# ASSESSMENT OF THE RICHMOND HILL III PARSHALL FLUME

### J. Marsalek

Environmental Hydraulics Section Hydraulics Division National Water Research Institute Canada Centre for Inland Waters Burlington, Ontario, Canada

October, 1986

Fig.1 Richmond Hill III Parshall Flume Layout (Dimensions in mm)

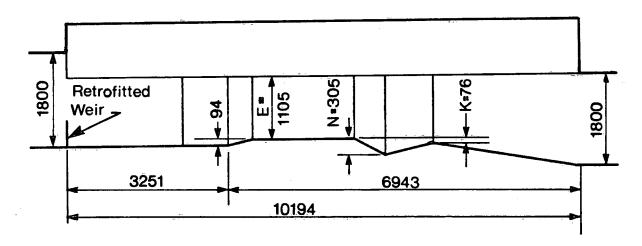
As the first step in the assessment of the RH Parshall flume, its dimensions are compared to those of the standard Parshall flume. The standard flume dimensions were adopted from the original reference, converted into metric units and presented in Table 1 (Parshall, 1950). In the same table, the dimensions of the RH flume, supplied by the client, are also shown. For further explanations of the individual dimensions, reference is made to a notation sketch in Fig. 1.

A comparison of the recommended and measured flume dimensions indicates a fairly good agreement. Although the recommended tolerances for Parshall flume dimensions are fairly strict and for the flume under consideration could be as small as ±10 mm (Parshall, 1950), they apply only to the critical dimensions, such as the flume throat width. For other dimensions, higher tolerances, in the order of several percents, are acceptable (Replogle, 1971). Considering the above tolerances, only two dimensions, W and N, show significant deviations. In the latter case, the depression in the flume bottom N was designed unnecessarily too deep, but there are no obvious reasons why this should affect the flume operation or the rating curve.

The deviation in the throat width W is more serious. It appears that the throat side walls are not planar and the west wall protrudes inward in the lower half. It was suggested in the literature that errors in W cause errors in discharge of the same relative

Besides the comparison of recommended and actual dimensions of the 1.83 m (6 ft) Parshall flume, there is a more fundamental consideration to be made - whether this flume size is appropriate for the 1800 mm pipe feeding into this installation. In order to obtain the flume entrance width P of 3580 mm (see Fig. 1), the installation includes a diffuser with an expansion angle of 20°. This arrangement is clearly causing problems because the expansion angle is too large and flow separation takes place. Such problems are further aggravated by the relatively fast feeding pipe flow which is characterized by Froude numbers as high as 0.9. Problems with flume operation caused by the malformed diffuser and high velocities led to recent flume modifications described below.

In an attempt to improve the RH flume performance, the flume geometry was modified by installing two vertical walls in the entrance section and placing a weir plate at the end of the 1800 mm pipe. The first measure attempts to correct the malformed diffuser and the second measure attempts to reduce the excessive inflow velocity. Velocity measurements in the flume entrance section (see Section 3) indicate that the above measures do not remedy the approach flow problems completely. It can be also concluded that the existing RH Parshall flume installation departs from the standard

Fig. 2 Parshall Flume attached to a pipe (After Chen et al., 1972)

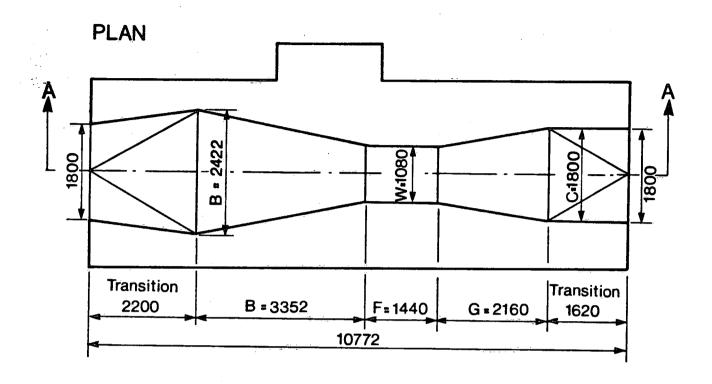
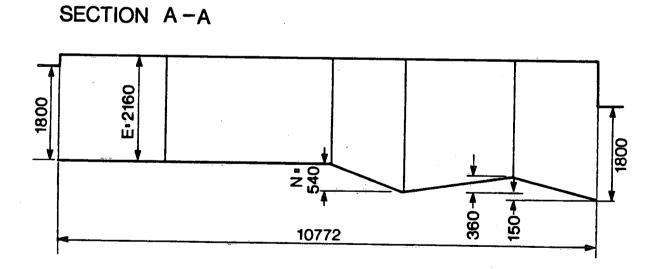
The problems encountered in the entrance section of the RH Parshall flume could have been avoided by reducing the slope (and thereby the velocity) of the 1800 mm pipe and using a modified Parshall flume designed for installation at the end of a circular pipe. Such a design is shown schematically in Fig. 2 (Chen et al., 1972).

Compared to the existing flume, the design in Fig. 2 has a narrower throat (1080 mm, compared to 1829), a smaller maximum inlet width (2422 mm, compared to 3580 mm in the original design), and a slightly greater overall length (10.772 m, compared to 10.194 m). It should be noted that this special flume could be fitted into the existing metering vault by reducing the downstream transition whose length is not critical for flume operation. Note also that the expansion angle of the diffuser in this special design is only 8°. The maximum flow rate for the flume shown in Fig. 2 was estimated as 1.710 m<sup>3</sup>/s. It should be emphasized that this flume layout is also non-standard and a special rating curve would have to be used.

The second option for improving the existing facility would be a complete redesign and reconstruction using the layout shown in Fig. 2. Such a measure would disrupt the operation of the existing installation and it would be quite costly. The redesigned flume would be non-standard and its rating curve would have to be determined from the literature data, or by calibration. For the above reasons, the redesign option is rather unattractive and should be

Fig.3 Observed velocities in the Richmond Hill III Parshall Flume.

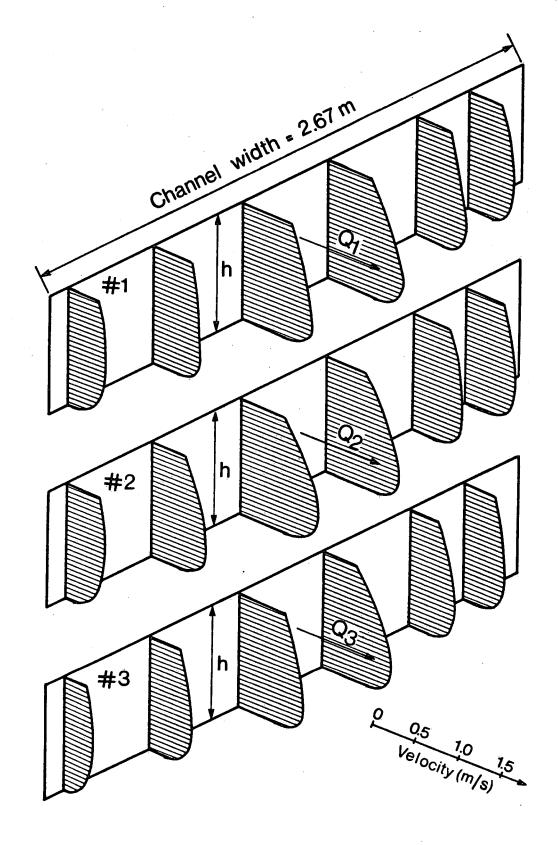
The results of flow velocity measurements are shown in Fig. 3. The velocity plots in Fig. 3 show high non-uniformity with marked vertical and horizontal gradients. Along the verticals, the highest velocities are found in the lower half of velocity profiles, particularly in the central part of the cross-section. This is caused by the flow of water over the weir at the end of the 1800 mm sewer pipe. Although this weir is helpful in reducing the approach velocity, which would be close to the critical velocity, it also distorts the normal velocity distribution.

In the lateral direction, the velocity profiles are fairly symmetrical with the highest velocities found in the central part. This is caused by the concentrated inflow of water from the 1800 mm pipe and inadequate diffusion of flow velocities across the full channel width.

The main value of the velocity data consists in their indication of highly nonuniform velocity distributions in the approach section of the RH flume. Such distributions then adversely affect the measuring accuracy of the RH flume as discussed in the preceding section. The velocity data were further used to estimate discharges through the RH flume. Towards this end, velocity profiles along verticals were drawn, graphically integrated and the mean velocities at each vertical determined. Using such mean velocities, the velocity profile across the channel was drawn, graphically integrated, and the mean cross-section velocity was determined. The discharge was then calculated as the product of the flow area and the mean cross-sectional velocity. All the measured discharges are listed in Table 2 together with the flow rates read from the charts recorded by the ultrasonic probe and the air bubbler.
